## Team Update 01

### Game Manual

Figure 7-2 NOTE movement limitations in AUTO

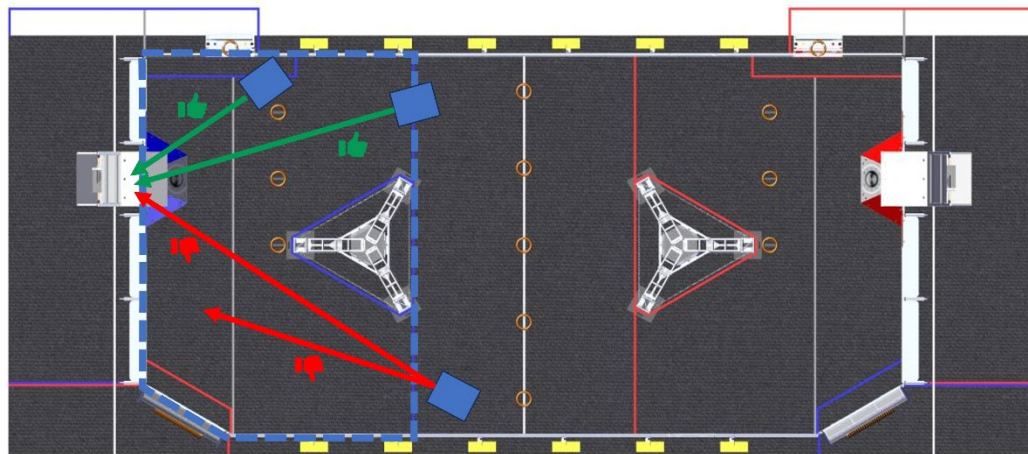
**G404 Only close shots in AUTO.** In AUTO, a ROBOT whose BUMPERS are completely outside their WING may not cause a NOTE to travel into or through their WING **such that the NOTE enters the WING while not in contact with that ROBOT.**

Figure 7-3 ROBOT height elaboration

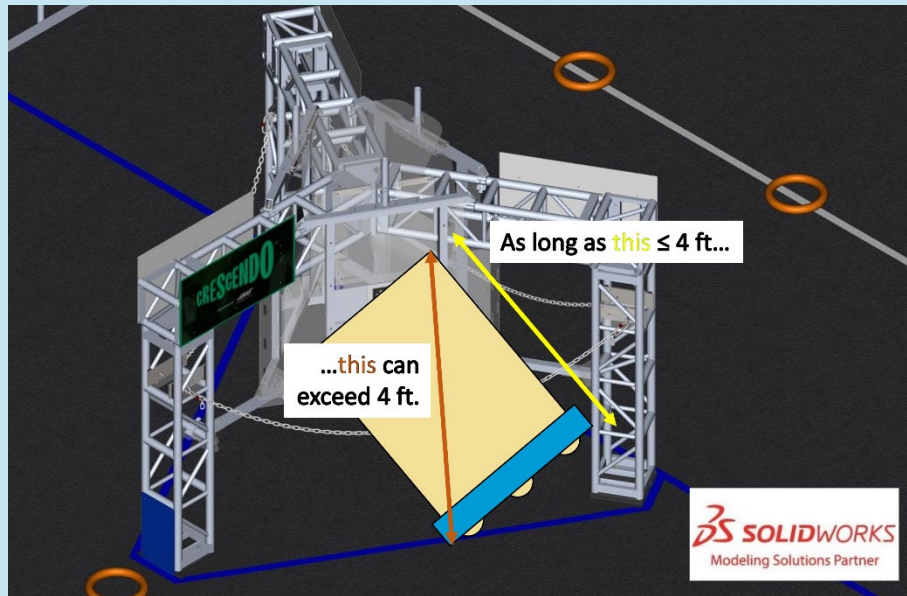
- it's height, as measured when it's resting normally on a flat floor, may not exceed 4 ft. (~132 cm) or 122 cm)
- it may not extend more than 1 ft. (~30 cm) from its FRAME PERIMETER.

Height is intended to be measured as if the ROBOT is resting on a flat floor, not relative to the height of the ROBOT from the FIELD carpet. For example, a ROBOT that is attempting to get ONSTAGE may actually exceed the height limit when compared to the carpet of the FIELD.
